Access Compliance Report

Public Rights-of-Way

(Curb Ramps)

Intersection ID: 43843	Main Street: DELUCA_DR	Cross Street: ROTHMAN_LN	Location:	E
ADA ID: 524F618D2328	Ramp Type: Perp	Initial Pass/Fail: Fail	Overall Compliance: No	Severity Score: 8.75
Codes/Mitigation Info/Possible Solution		Field Measurements/Component Compliance

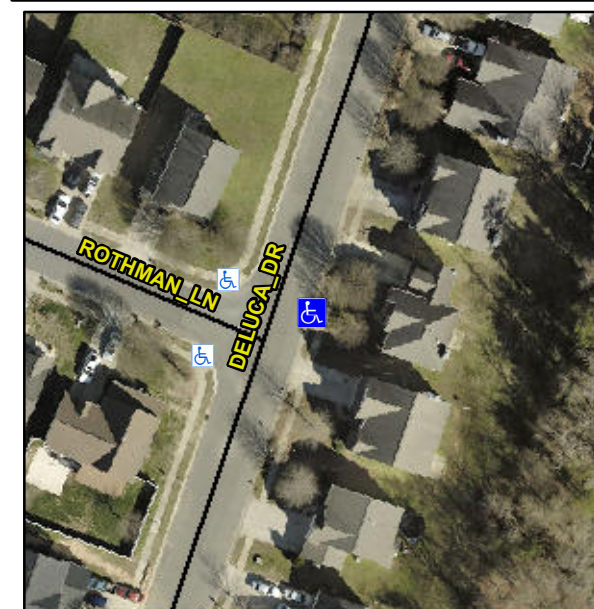
Not Found, R304.5.1

Compliance	Description	Data	Compliance	Description	Data
N/A	Ramp Length (in)	48.0	Yes	Ramp Slope (%)	7.7
No	Ramp Width (in)	47.0	Yes	Ramp XSlope (%)	1.1
N/A	Flare Type LT	N/A	N/A	Flare Type RT	N/A
N/A	Flare Slope LT (%)	N/A	N/A	Flare Slope RT (%)	N/A
N/A	Flare Traversable LT?	N/A	N/A	Flare Traversable RT?	N/A
N/A	Landing Length (in)	N/A	N/A	DWS Provided?	N/A
N/A	Landing Width (in)	N/A	N/A	DWS Contrast?	N/A
N/A	Landing Slope (%)	N/A	N/A	DWS Length (in)	N/A
N/A	Landing X Slope (%)	N/A	N/A	DWS Full Width?	N/A
N/A	Landing Curb? (Y/N)	N/A	N/A	DWS Offset (in)	N/A
N/A	Shared Landing?	N/A			
N/A	Gutter Ponding?	N/A	N/A	Gutter Slope (%)	N/A
N/A	Gutter Lip Ht (in)	N/A	N/A	Gutter X Slope (%)	N/A
N/A	Painted X Walk1?	No	N/A	Painted X Walk2?	N/A
	X Walk 1 Direction	To NW		X Walk 2 Direction	N/A
N/A	X Walk 1 Width (in)	N/A	N/A	X Walk 2 Width (in)	N/A
	X Walk 1 Slope (%)	1.1		X Walk 2 Slope (%)	N/A
	X Walk 1 X Slope (%)	1.3		X Walk 2 X Slope (%)	N/A

Remove & Replace Entire Ramp.
